DETERMINATION OF NON-SIGNIFICANCE

NAME & DESCRIPTION OF PROPOSAL: Reidinger Addition

**City of Bellevue
Development Services Department
Land Use Staff Report**

File Number: 13112256-LO

PLOT PLAN

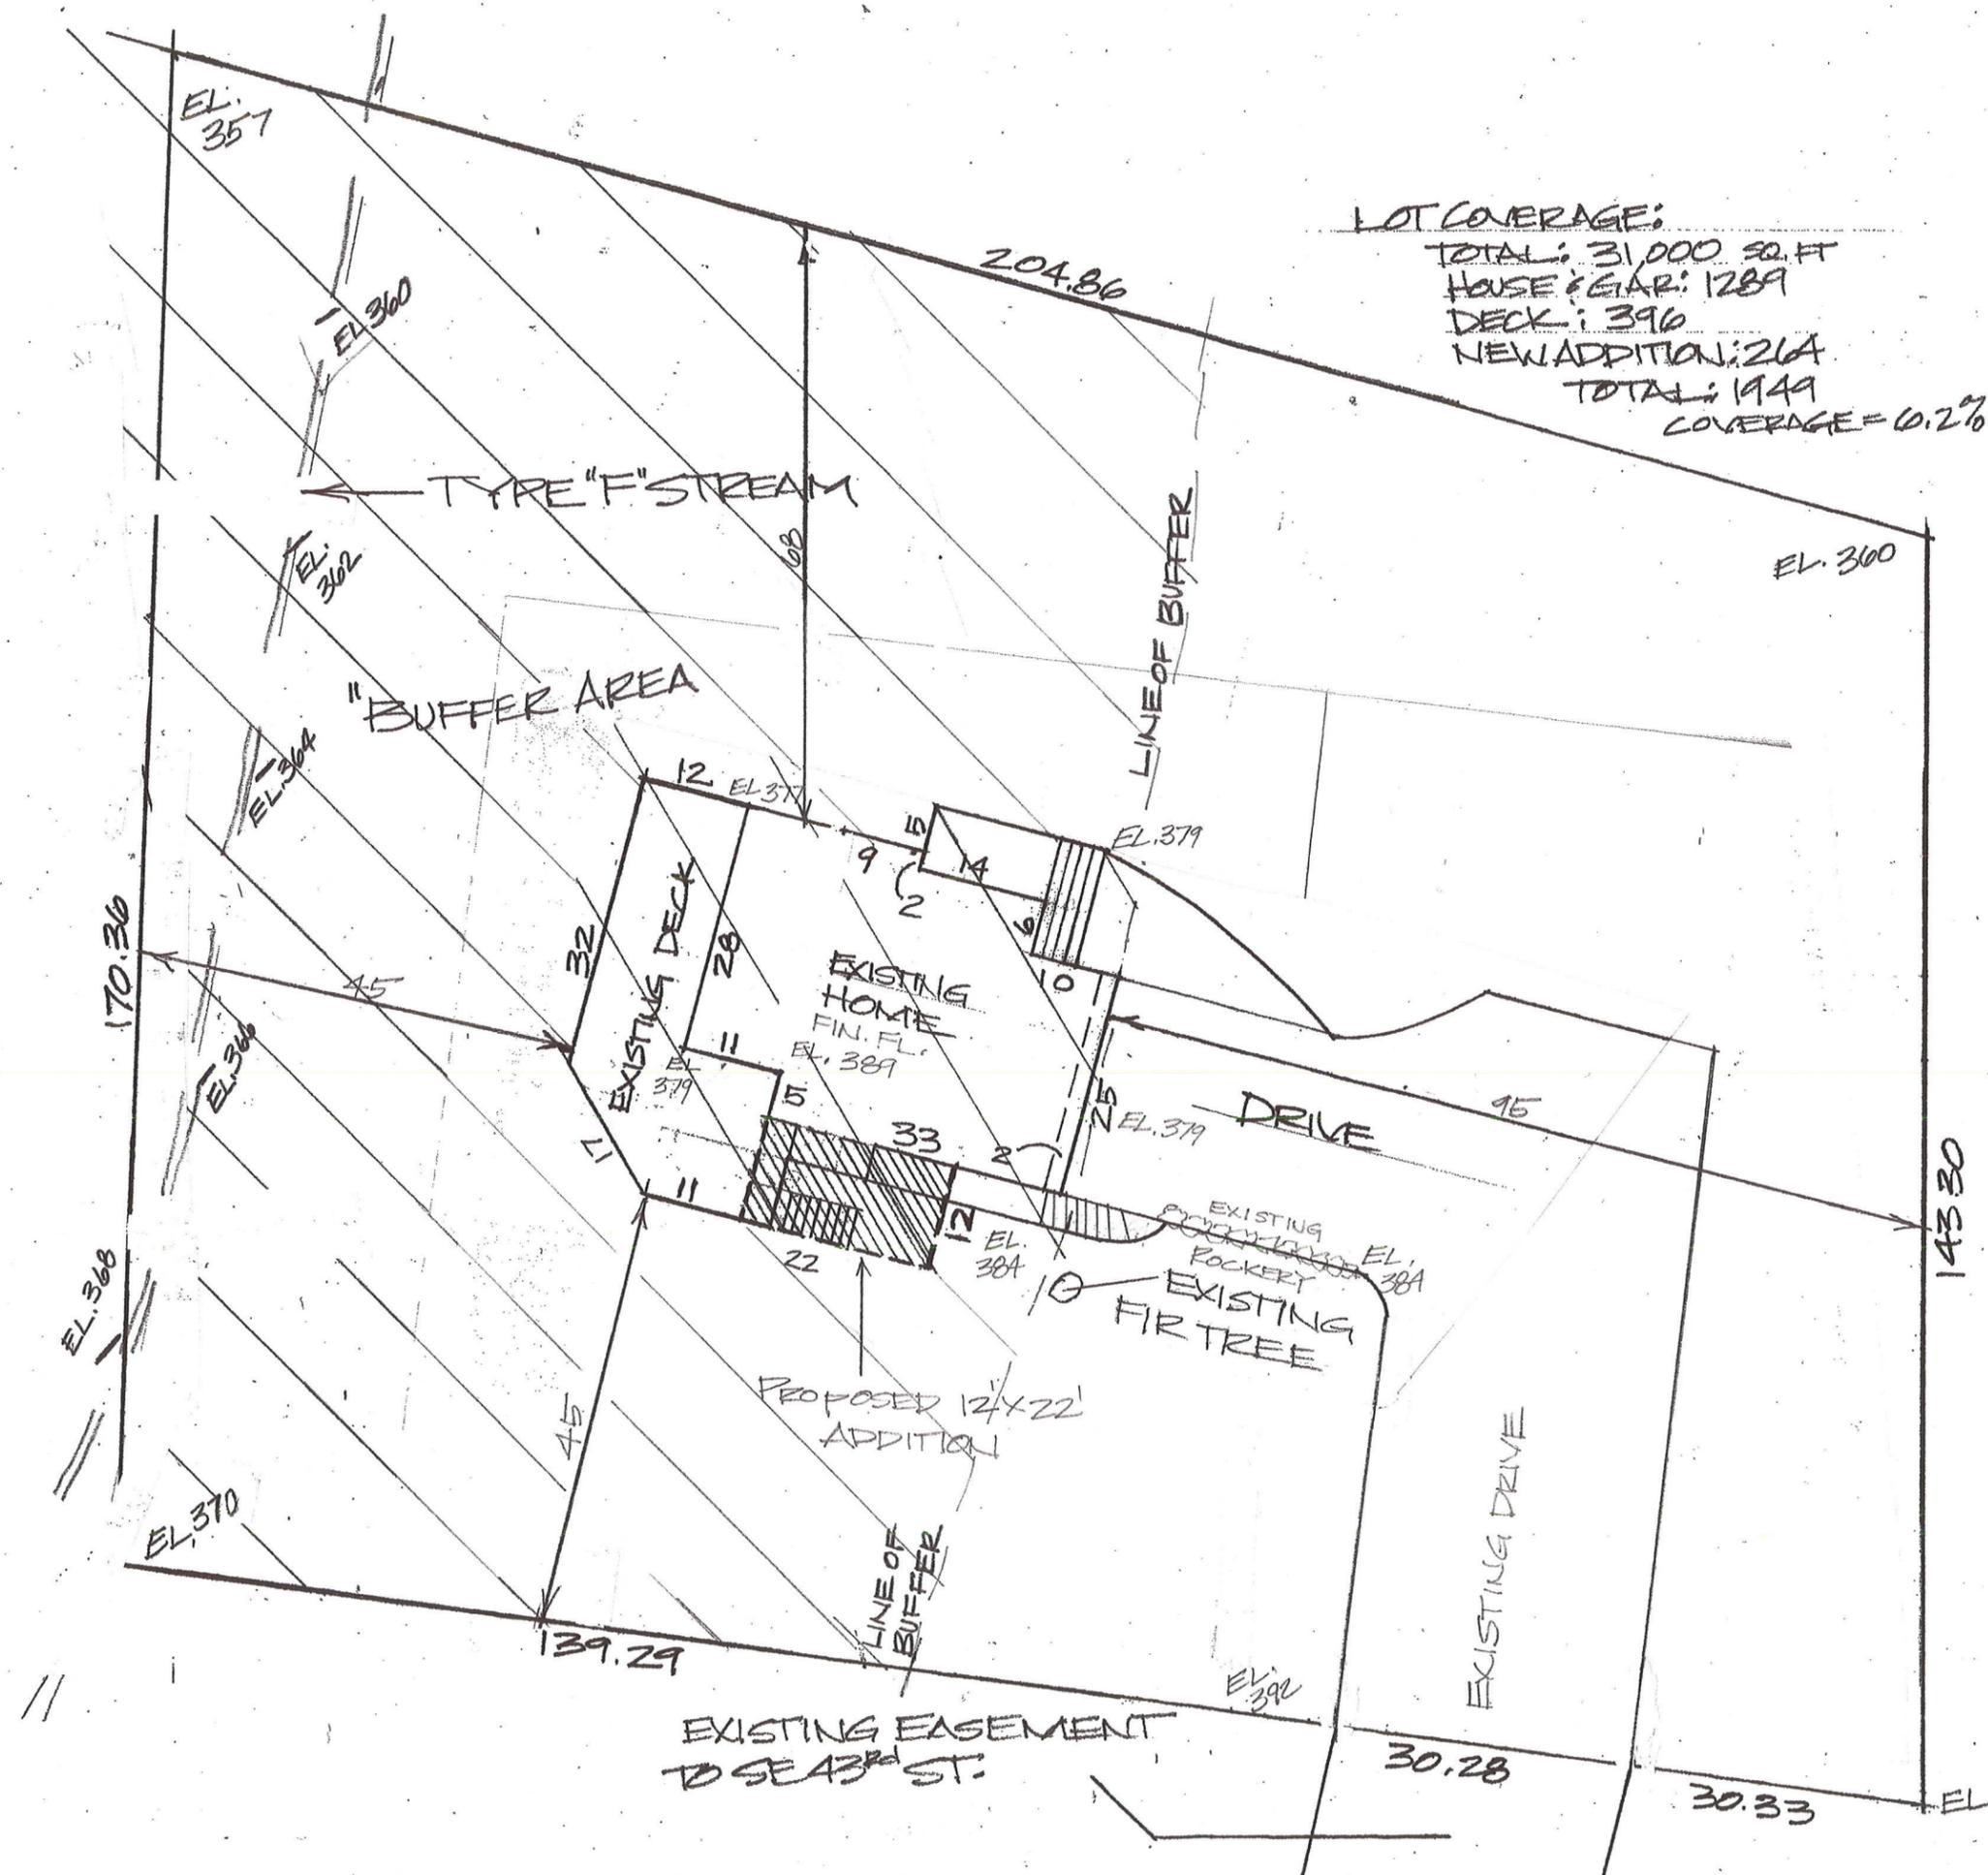
Finding: The proposed addition is near the outer edge of the buffer at the top of the ravine. All lights and noises will be directed away from the stream based on topography and the location of the house relative to the stream. No toxic runoff will be generated by the home addition. Drainage will flow across the site and be filtered by vegetation before entering the stream. In exchange for approval the site is required to be planted with at least 268 square feet of native planting. The planting can be selected from the City’s planting template for stream buffers which is Attachment 2 of this report. The site plans submitted for the building permit application shall be revised to show the designated planting area. The planting is recommended to be placed at the top of the ravine to address the standard above

for planting at the outer edge of the stream buffer. The site plan shall designate the species of plants and quantity to be planted with trees spaced at a maximum of 9 feet on center, shrubs spaced at a maximum of 4.5 feet on center, and ground covers at a maximum of 2 feet on center. Based on the planting area of 268 square feet and the spacing requirements the planting should include at least 3 trees, 14 shrubs, and 100 ground covers. See Conditions of Approval in Section X of this report.

The proposed expansion maintains the existing building line parallel to the top of bank. The entire house is located within the buffer which requires the proposed addition to the kitchen and bathroom to be located within the buffer as the intended use cannot be realized outside the buffer. The addition is not intruding further into the buffer than the existing house is already located.

The proposed addition will expand the footprint by 268 square feet which is less than the 500 foot expansion allowed. The kitchen and master bathroom cannot be easily moved to another location in the house.

- 2. Mitigation Planting:** Plans submitted for the building permit must show, on a separate sheet, a final mitigation plan for the 268 square feet area determined to be permanent impact resulting from the house addition within the stream buffer. Mitigation planting must, at a minimum, match the City's planting templates for stream buffers found as attachment 2 of this report. The planting area must contain at least 3 trees, 14 shrubs, and 100 ground covers based on the required planting density of the template.

STREAM BUFFER STEEP SLOPE PLANTING TEMPLATE

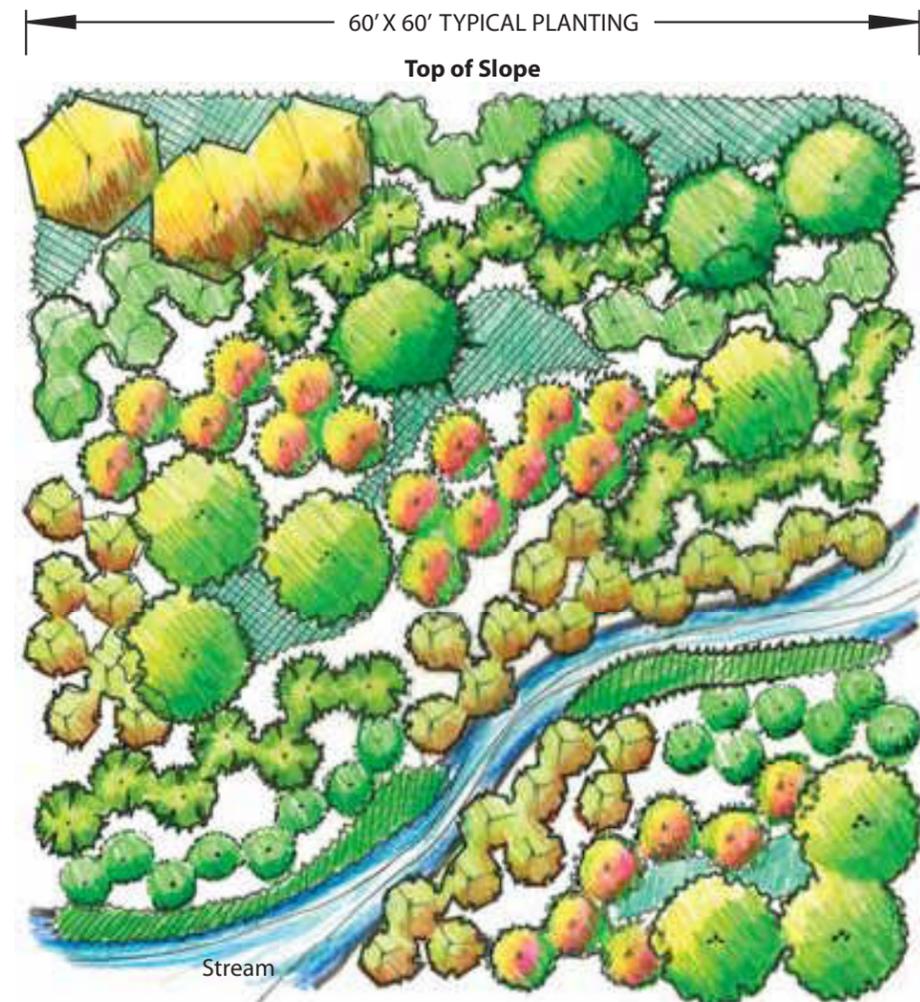
268 square feet of planting is required per the City's planting templates for stream buffers as explained previously.
